Access Compliance Report

Public Rights-of-Way

Intersection ID: 23730	Main Street: PROVIDENCE_RD	Cross Street: CEDAR_CROFT_DR	Location: NE
ADA ID: 0B159C309E95	Ramp Type: Perp	Initial Pass/Fail: Fail	Overall Compliance: No
		Severity Score: 22.5

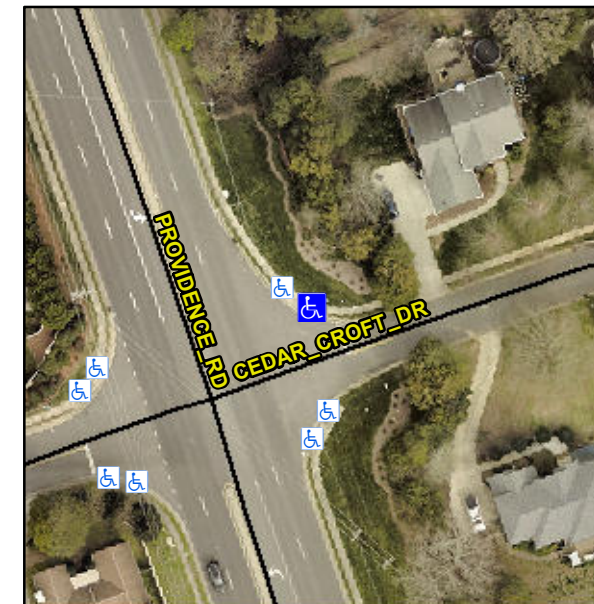
R304.5.1, R304.2.2, R304.5.3

Compliance	Description	Data	Compliance	Description	Data
N/A	Ramp Length (in)	73.0	No	Ramp Slope (%)	8.6
No	Ramp Width (in)	46.5	No	Ramp XSlope (%)	4.6
N/A	Flare Type LT	N/A	N/A	Flare Type RT	N/A
N/A	Flare Slope LT (%)	N/A	N/A	Flare Slope RT (%)	N/A
N/A	Flare Traversable LT?	N/A	N/A	Flare Traversable RT?	N/A
N/A	Landing Length (in)	N/A	N/A	DWS Provided?	N/A
N/A	Landing Width (in)	N/A	N/A	DWS Contrast?	N/A
N/A	Landing Slope (%)	N/A	N/A	DWS Length (in)	N/A
N/A	Landing X Slope (%)	N/A	N/A	DWS Full Width?	N/A
N/A	Landing Curb? (Y/N)	N/A	N/A	DWS Offset (in)	N/A
N/A	Shared Landing?	N/A			
N/A	Gutter Ponding?	N/A	N/A	Gutter Slope (%)	N/A
N/A	Gutter Lip Ht (in)	N/A	N/A	Gutter X Slope (%)	N/A
N/A	Painted X Walk1?	No	N/A	Painted X Walk2?	N/A
	X Walk 1 Direction	To SE		X Walk 2 Direction	N/A
N/A	X Walk 1 Width (in)	N/A	N/A	X Walk 2 Width (in)	N/A
	X Walk 1 Slope (%)	0.4		X Walk 2 Slope (%)	N/A
	X Walk 1 X Slope (%)	3.9		X Walk 2 X Slope (%)	N/A

Remove & Replace Entire Ramp.
